APICAL INDUSTRIES, INC.
dba DART AEROSPACE

ENGINEERING CHANGE NOTICE NO. 05811

DWG NO. 646.7400 REV: A

DWG TITLE: FLOAT RESERVOIR ASSY

SHEET 1, NOTES IS:

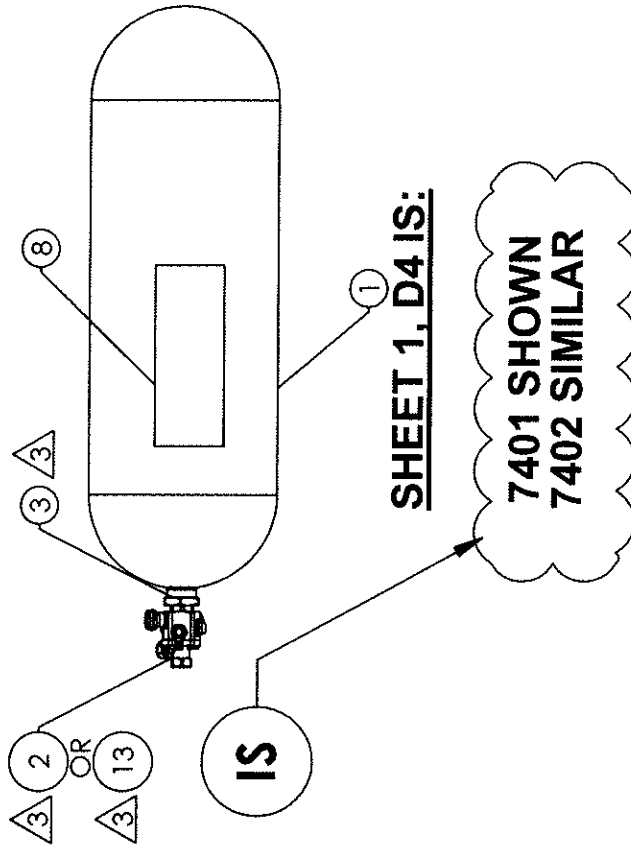
REASON: PART NUMBER DOES NOT MATCH SHOWN VALVE

5 ~~FILL PRESSURE: 4550 ± 50 PSIAW-MPP-157~~

6 VISUALIZATION OF VALVE FOR REFERENCE ONLY, ASSEMBLE TO PART NUMBER

SHEET 1, NOTES, IS:

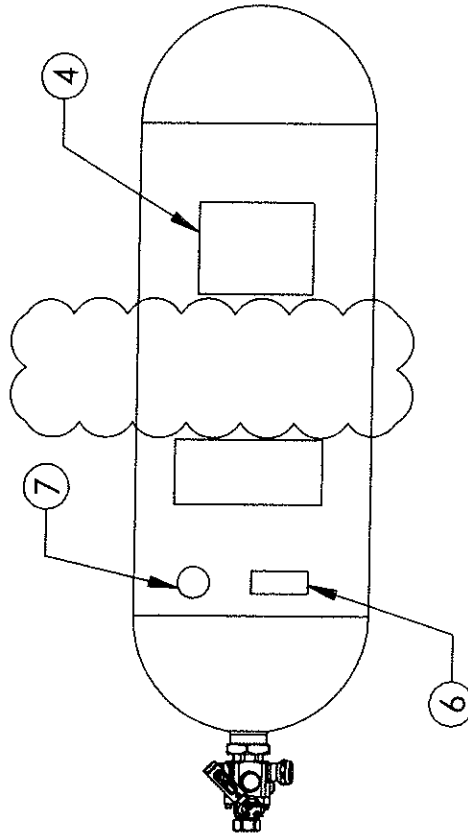
REASON: ADDED FILL PRESSURE AND REVISED DRAWING VIEW

- 1 IDENTIFY IAW MPP-120.
- 2 GRAPH LABELS F/N 10 TO BE INSTALLED IN LINE WITH PRESSURE GAUGE.
- 3 TORQUE TO 40 FT. LBS.
- 4 VENDOR: CARLETON
VENDOR P/N: 6289
- 5 FILL PRESSURE: 4500 ± 50 PSI IAW MPP-157
